**PUBLIC UTILITY COMMISSION OF OREGON
STAFF REPORT
PUBLIC MEETING DATE: June 29, 2021**

SUBJECT: PORTLAND GENERAL ELECTRIC:
(Docket No. UM 1728)
Updates to Schedule 201, Qualifying Facility (10 MW or Less) Avoided
Cost Information.

Figure 1: Solar renewable \$/MWh flat forecast

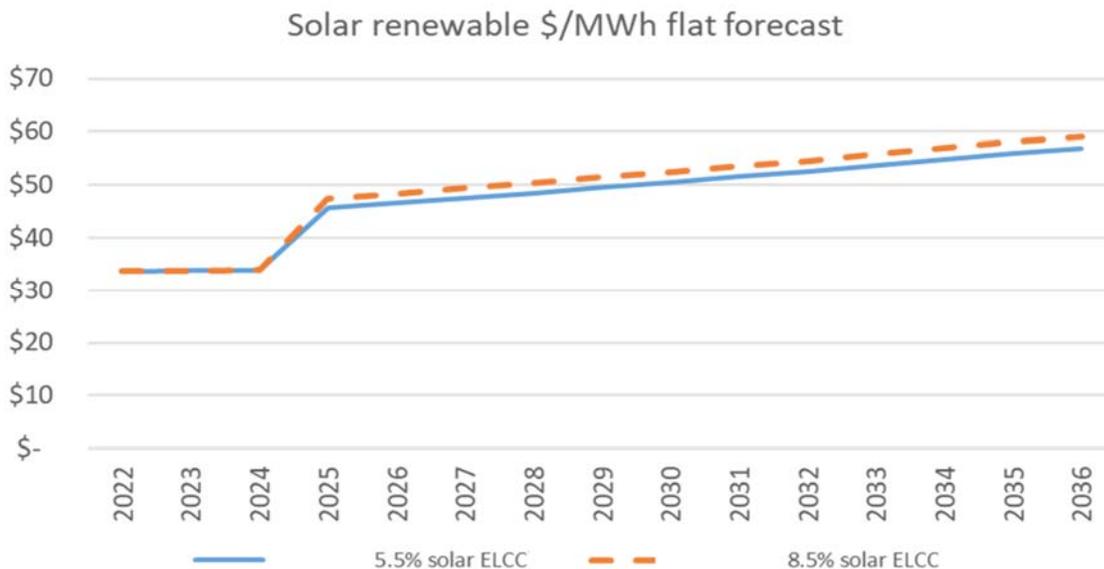
Replacing PGE’s as filed 5.5 percent solar ELCC with the recommended value of an 8.5 percent solar ELCC increases solar capacity payments and raises the total solar payments after the resource deficiency year of 2025 as shown in Figure 1.
